TEK-TIP

Steering Bearing

Pre 1979 Steering Stem Modification

STOCK STEERING STEM

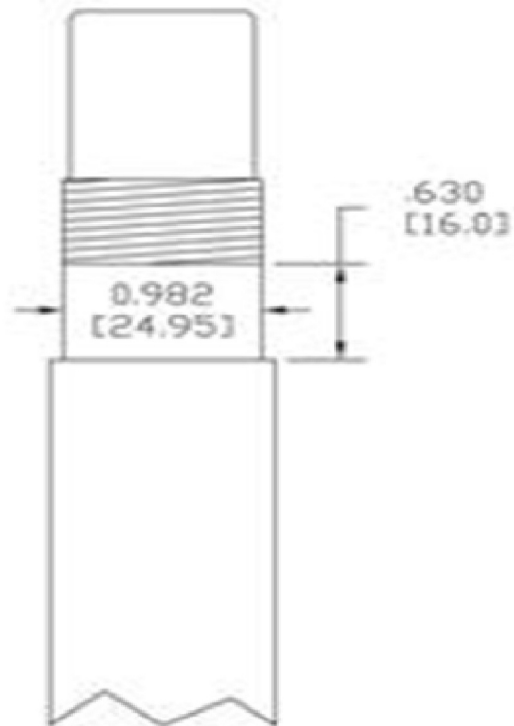
In order to install tapered bearings on early Suzuki's it may be necessary to modify the steering stem as per this sketch. When the stem is modified verify the bearing will slip into place.
